Access Compliance Report

Public Rights-of-Way

(Curb Ramps)

Intersection ID: 12380	Main Street: GREAT_WAGON_RD	Cross Street: SHAMROCK_DR	Location: SW
ADA ID: B7E6C241C47A	Ramp Type: Perp	Initial Pass/Fail: Fail	Overall Compliance: No
			Severity Score: 21.25

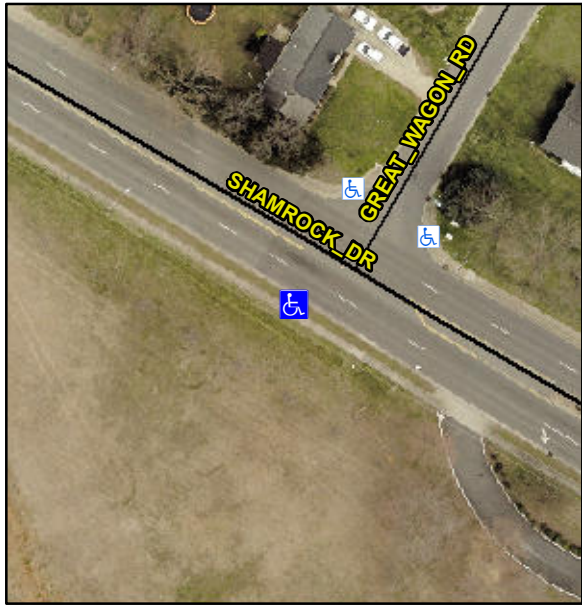
Codes/Mitigation Info/Possible Solution			Field Measurements/Component Compliance					
	Possible Solutions:		Compliance	Description	Data	Compliance	Description	Data
	Remove & Replace Entire Ramp.		N/A	Ramp Length (in)	47.5	No	Ramp Slope (%)	9.7
			No	Ramp Width (in)	44.0	Yes	Ramp XSlope (%)	1.7
			N/A	Flare Type LT	N/A	N/A	Flare Type RT	N/A
			N/A	Flare Slope LT (%)	N/A	N/A	Flare Slope RT (%)	N/A
			N/A	Flare Traversable LT?	N/A	N/A	Flare Traversable RT?	N/A
			N/A	Landing Length (in)	N/A	N/A	DWS Provided?	N/A
			N/A	Landing Width (in)	N/A	N/A	DWS Contrast?	N/A
			N/A	Landing Slope (%)	N/A	N/A	DWS Length (in)	N/A
			N/A	Landing X Slope (%)	N/A	N/A	DWS Full Width?	N/A
Surveyor Notes:			N/A	Landing Curb? (Y/N)	N/A	N/A	DWS Offset (in)	N/A
N/A			N/A	Shared Landing?	N/A			
PROW/ADA:			N/A	Gutter Ponding?	N/A	N/A	Gutter Slope (%)	N/A
Not Found, R304.5.1, R304.2.2			N/A	Gutter Lip Ht (in)	N/A	N/A	Gutter X Slope (%)	N/A

N/A	Painted X Walk1?	No	N/A	Painted X Walk2?	N/A
				X Walk 1 Direction	To NE		X Walk 2 Direction	N/A
			N/A	X Walk 1 Width (in)	N/A	N/A	X Walk 2 Width (in)	N/A
				X Walk 1 Slope (%)	1.6		X Walk 2 Slope (%)	N/A
				X Walk 1 X Slope (%)	2.8		X Walk 2 X Slope (%)	N/A
			N/A	Ramp inside XWalk1?	N/A	N/A	Ramp inside XWalk2?	N/A
				Road Slope (%)	N/A	N/A	Clear Space?	N/A
				Road X Slope (%)	N/A	N/A	Clear Space to XWalk (in)	N/A
			N/A	Any Obstructions?	N/A	N/A	Storm Grate/Utility Hazard?	N/A
				Obstruction Type			Storm Grate/Utility Type	
						N/A		N/A
						Yes	Surface Condition? (G/P)	Good
Total Cost:		\$ 1850.00
